Access Compliance Report

Public Rights-of-Way

Intersection ID: 24414	Main Street: MICHAEL_SHANE_CT	Cross Street: WRIGHT'S_FERRY_RD	Location: SW
ADA ID: 1E9B91B21E4C	Ramp Type: BlendTrans2	Initial Pass/Fail: Pass	Overall Compliance: No
		Severity Score: 10

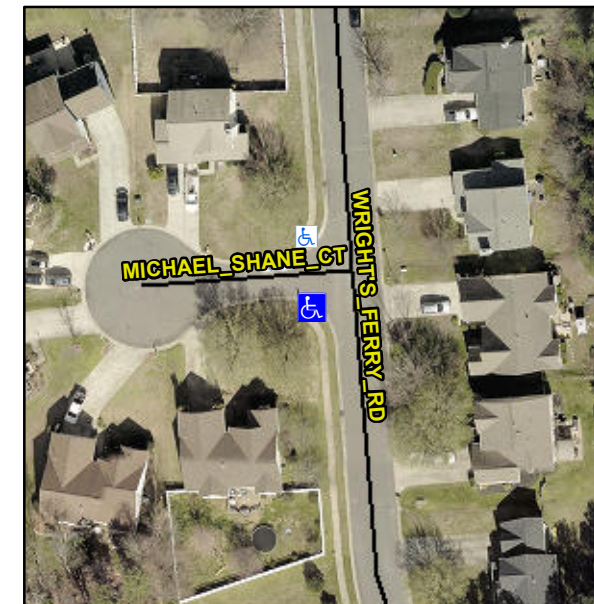
Compliance	Description	Data	Compliance	Description	Data
N/A	Ramp Length (in)	94.3	Yes	BlendTrans Slope (%)	2.3
Yes	Ramp Width (in)	83.5	Yes	BlendTrans XSlope (%)	0.7
N/A	Flare Type LT	None	N/A	Flare Type RT	None
N/A	Flare Slope LT (%)	N/A	N/A	Flare Slope RT (%)	N/A
N/A	Flare Traversable LT?	N/A	N/A	Flare Traversable RT?	N/A
N/A	Landing Length (in)	N/A	No	DWS Provided?	No
N/A	Landing Width (in)	N/A	N/A	DWS Contrast?	No
N/A	Landing Slope (%)	N/A	N/A	DWS Length (in)	N/A
N/A	Landing X Slope (%)	N/A	N/A	DWS Full Width?	No
N/A	Landing Curb? (Y/N)	No	N/A	DWS Offset (in)	N/A
N/A	Shared Landing?	No			
Yes	Gutter Ponding?	No	Yes	Gutter Slope (%)	3.1
Yes	Gutter Lip Ht (in)	0.0	Yes	Gutter X Slope (%)	1.9
N/A	Painted X Walk1?	No	N/A	Painted X Walk2?	No
	X Walk 1 Direction	To E		X Walk 2 Direction	To N
	X Walk 1 Width (in)	N/A		X Walk 2 Width (in)	N/A
	X Walk 1 Slope (%)	3.8		X Walk 2 Slope (%)	0.5
	X Walk 1 X Slope (%)	2.5		X Walk 2 X Slope (%)	0.2

N/A	Ramp inside XWalk1?	N/A	N/A	Ramp inside XWalk2?	N/A
	Road Slope (%)	1.7		Clear Space?	Yes
	Road X Slope (%)	6.1	N/A	Clear Space to XWalk (in)	N/A
Yes	Any Obstructions?	No	Yes	Storm Grate/Utility Hazard?	No
	Obstruction Type			Storm Grate/Utility Type	
		N/A			N/A
			Yes	Surface Condition? (G/P)	Good
			No	Curb Slope (%)	13.6

Remove & Replace Curb Ramp With Two New Directional Ramps or Equivalent.
